Log # TXX-88467
File # 10010
Ref 10CFR2.102(a)

June 1, 1988

William G. Council
Executive Vice President

SUBJECT: COMANCHE PEAK STEAM ELECTRIC STATION (CPSES)
DOCKET NOS. 50-445 AND 50-446
EVALUATION OF CHANGES TO FINAL SAFETY ANALYSIS REPORT

FIGURE 1

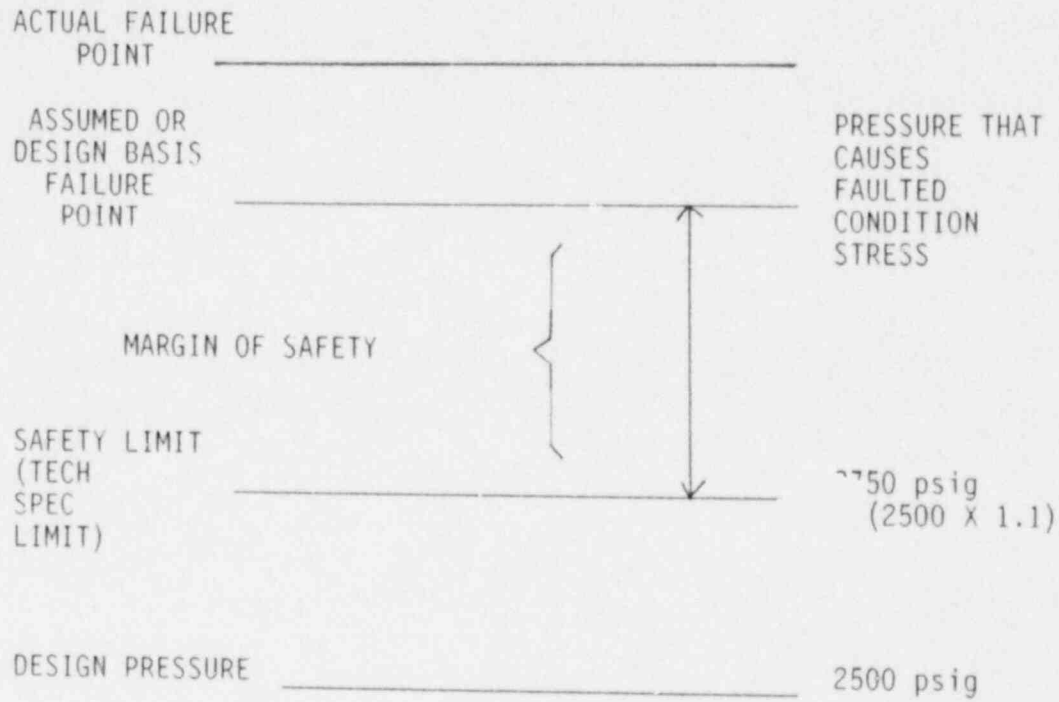
This "significance" test is illustrated in an example in Figure 1. Case 1 in the example does not involve a significant increase in consequences; cases 2, 3, and 4 do involve a significant increase.
